REQUEST Current Zoning: R-3 (single family residential)
Proposed Zoning: R-12MF(CD) (multi-family residential, conditional)

LOCATION Approximately 19.52 acres located on the north side of Mallard Creek Road, east of Interstate 485.
(Outside City Limits)

SUMMARY OF PETITION

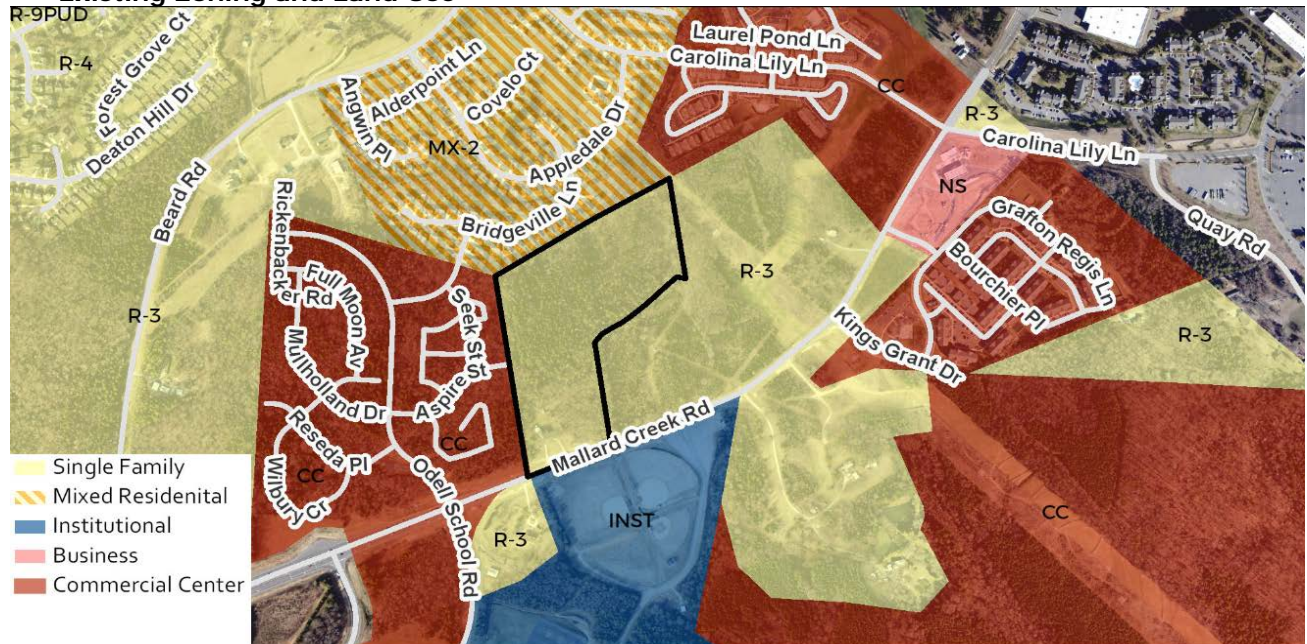
1. The petitioner should revise the site plan and conditional note(s) to provide a northbound left turn lane from Mallard Creek to the proposed local private street. The access at Mallard Creek Road may otherwise be restricted to right-in/right-out.
2. The NCDOT is planning a widening project (U-6032) and may revise the future curblin along the site's Mallard Creek Road frontage during permitting.
3. No on street parking. Dead end access exceeding 150 feet requires approved Charlotte Fire Department turnaround. See charlottefire.org for other requirements. Petitioner should coordinate with Charlotte Fire to resolve this issue.

4. Please correct stream buffer labels to specify 50-foot Undisturbed PCSO buffer. Please also add the following note under the ENVIRONMENTAL FEATURES heading: "For adjoining parcels receiving stormwater discharge from proposed BMP(s), the Petitioner shall analyze adequacy of the existing stormwater conveyance on the adjoining parcels. If the existing stormwater conveyance on the adjoining parcels is found to be inadequate, the Petitioner shall make a good faith effort with the property owner(s) to improve the stormwater conveyance or otherwise mitigate the stormwater discharge onto the adjoining parcels."
5. Please correct stream buffer delineations and labels on the site plans. Within this watershed, all intermittent and perennial streams draining less than 50 acres require a 50-foot undisturbed PCSO buffer (the 35-foot buffer delineations are incorrect).

6. Under Development Data Table specify maximum number of stories and building height.
7. Please shift required Class C buffer out of the 150-foot Duke Energy transmission right-of-way.
8. Remove drawing on technical data plan sheet.
9. Revise Note 1.C under General Provisions to clarify that only minor amendments that do not change the intent of the plan will be allowed.
